MAYBERRY COMMUNITIES MASTER DEVELOPMENT DRAINAGE PLAN

**R&R JOB #MC22208
EPC PROJECT NO. SKP236**

**ORIGINAL SUBMITTAL DATE: JULY 2023
SUBMITTAL: SEPTEMBER 2024**

**HISTORIC
DRAINAGE PLAN**

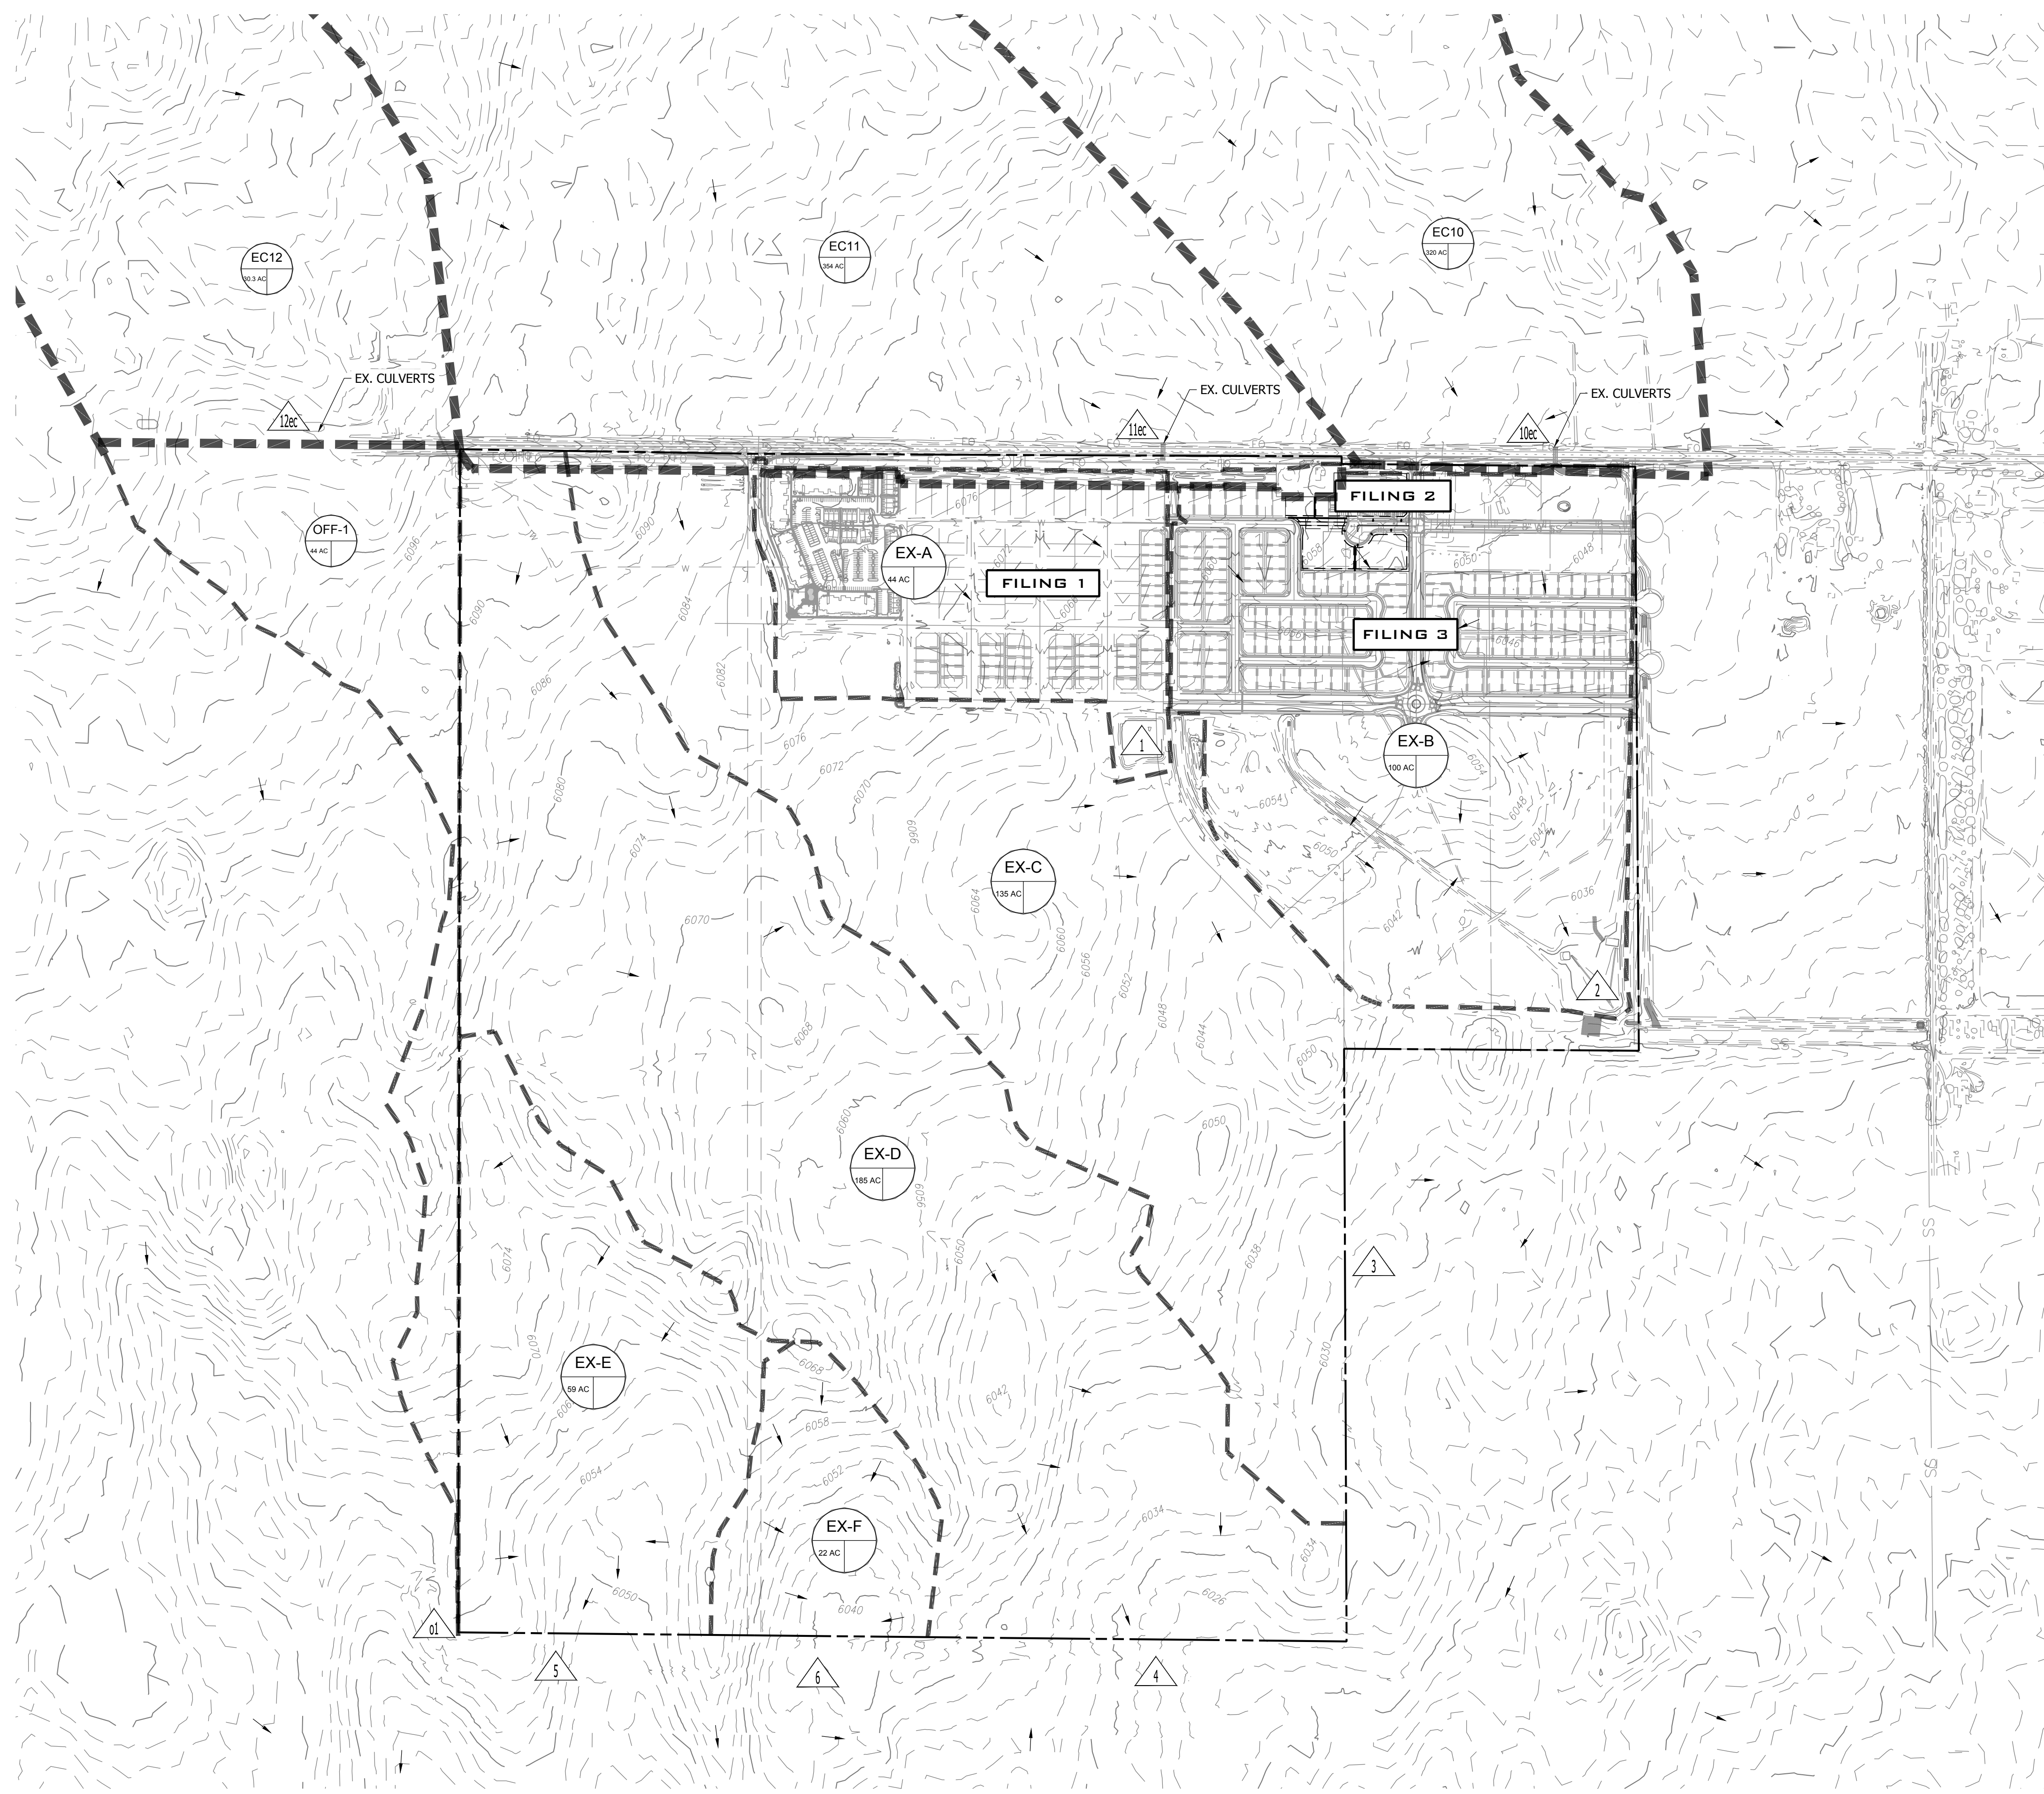
Unresolved from Submittal 1: address any transfer of flows. The drainage maps appear to show shifting drainage basin lines.

This section has been enhanced to discuss the shifting of drainage basin lines for the historic Ellicott Consolidated and Telephone Exchange drainage basins. In addition, drainage plan sheet, DR6 has been enhanced to provide shading/labeling of this drainage basin change.

OVERALL PROPOSED DRAINAGE MAP
 DR3

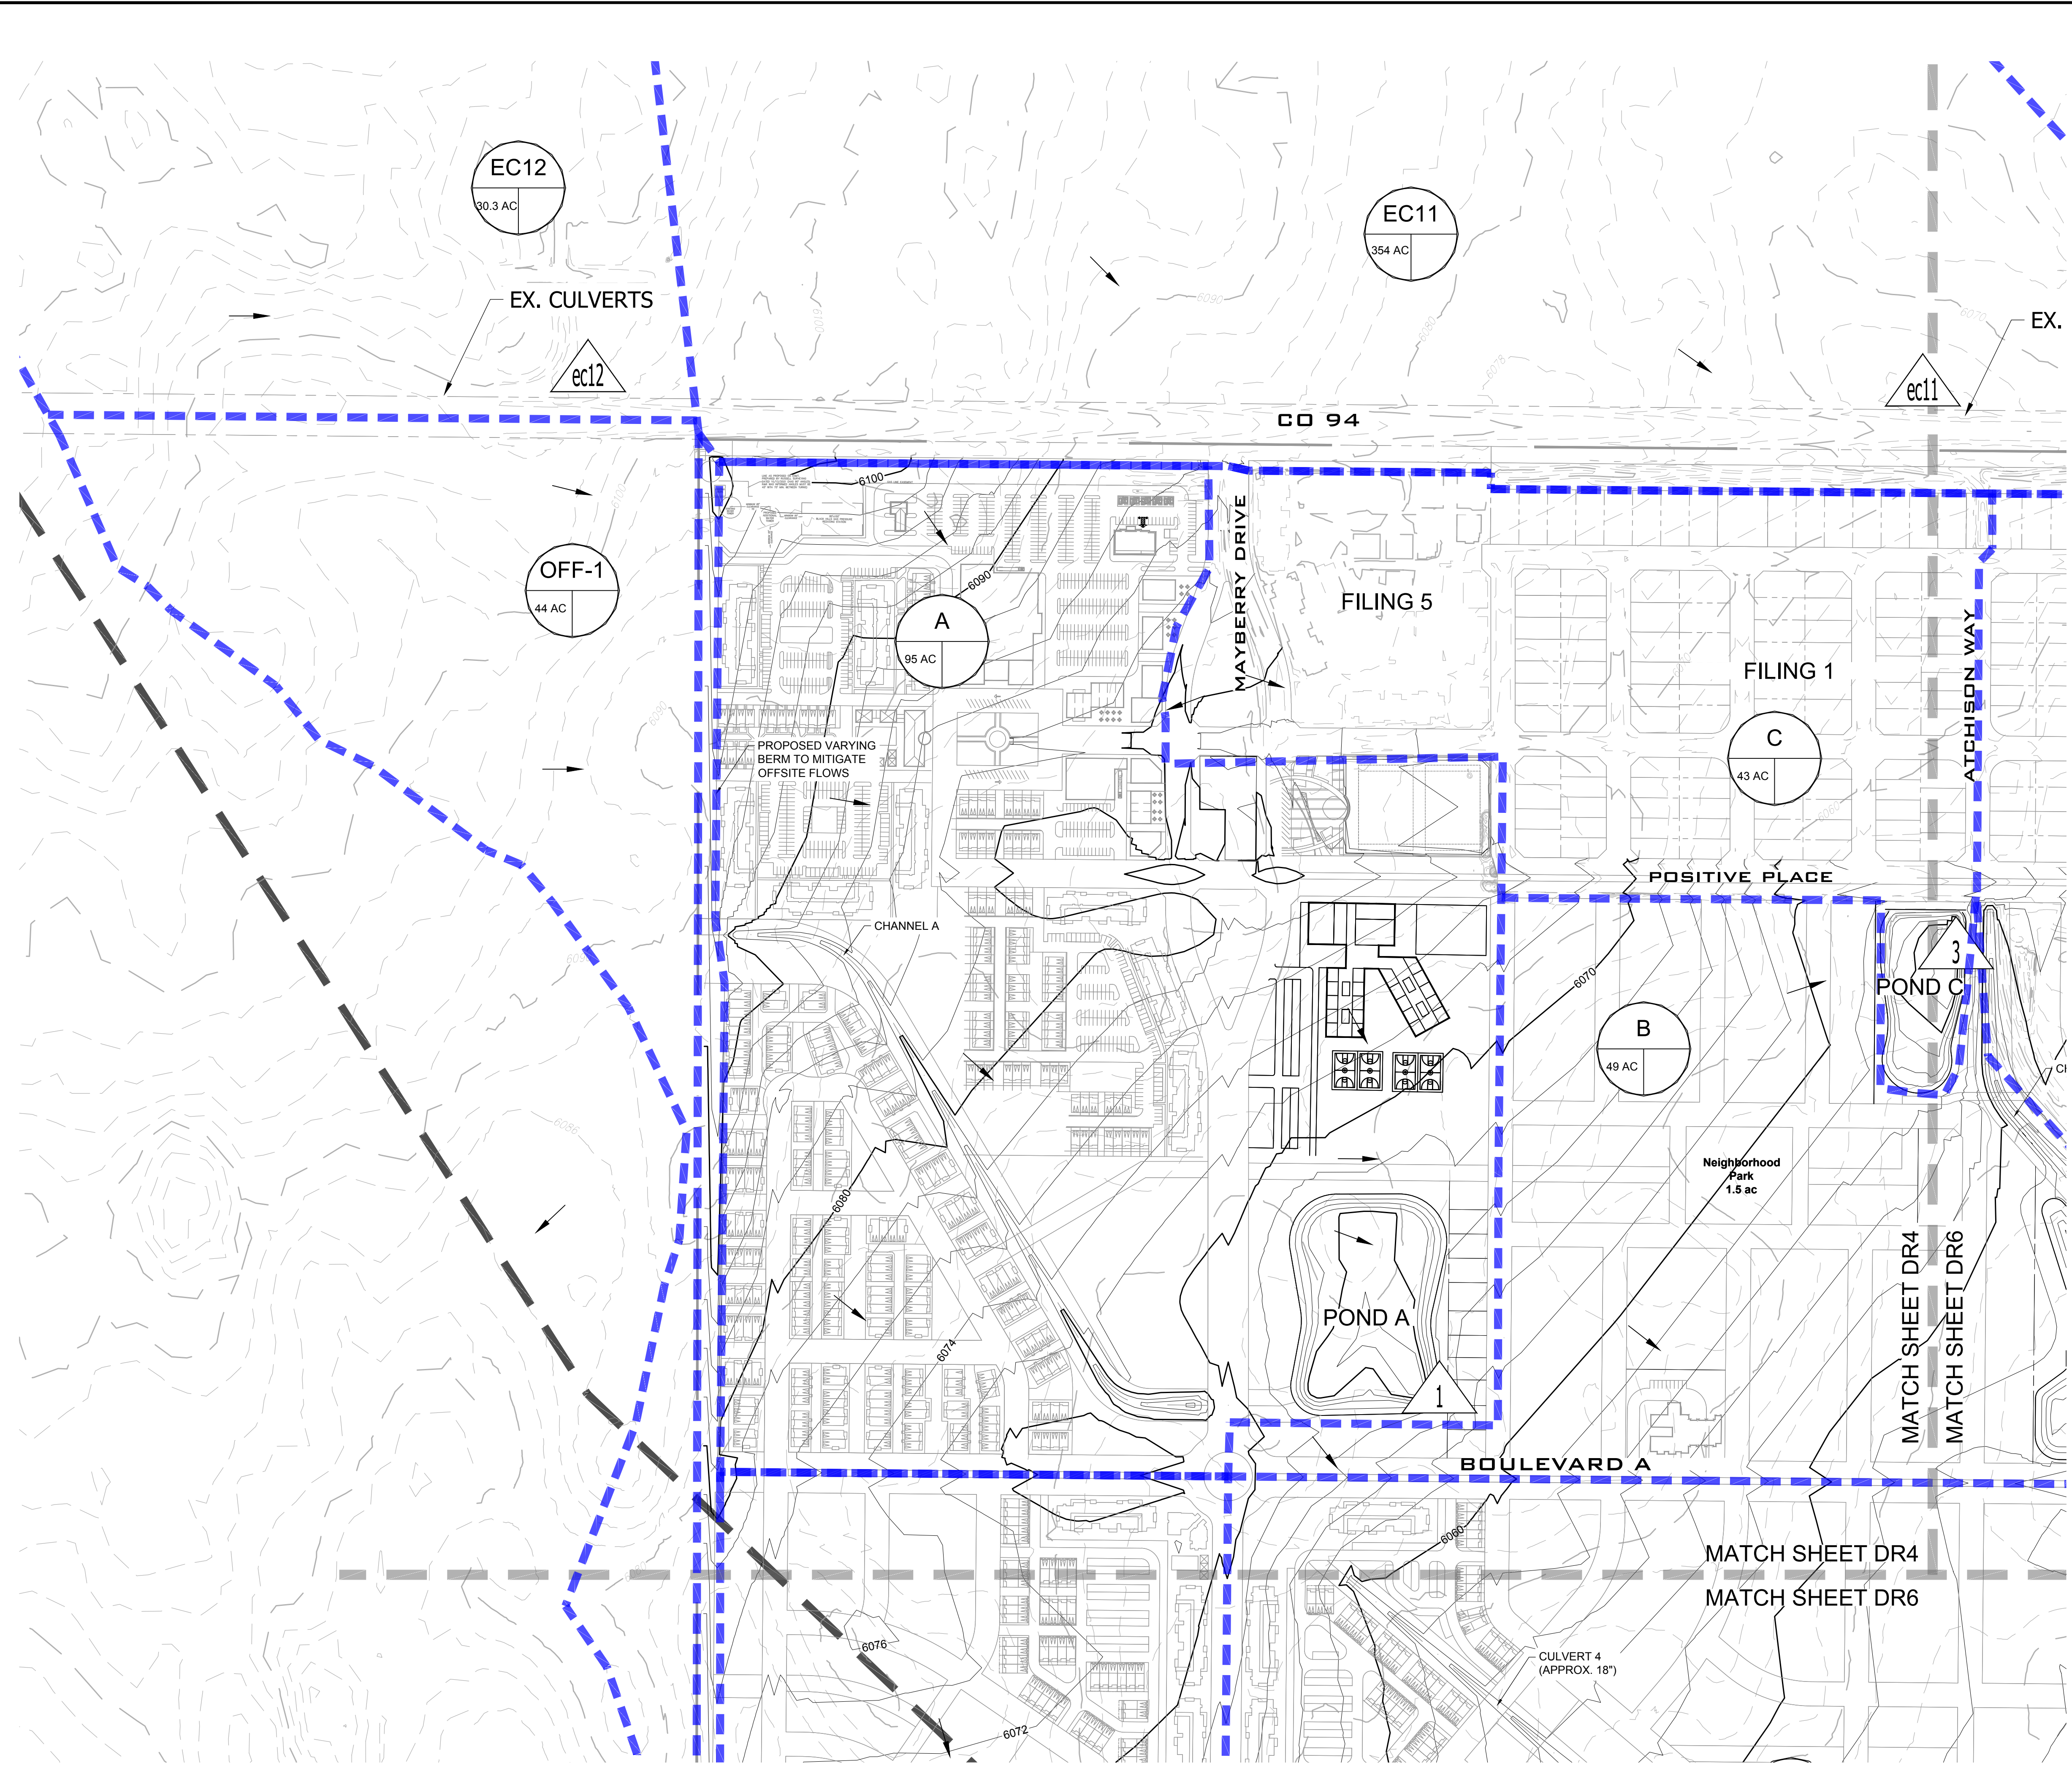
Road name has been revised accordingly.

Discuss the drainage shift with the Telephone Exchange and Ellicott Consolidated Drainage Basins in the drainage text and quantify the change.

Road name has been revised accordingly.

A discussion is now provided in the drainage report in section IIA to highlight the drainage shift of the Telephone Exchange and Ellicott Consolidated drainage basins. In addition, hatching and labels have been provided on Drainage sheet DR6 which also provides quantities.
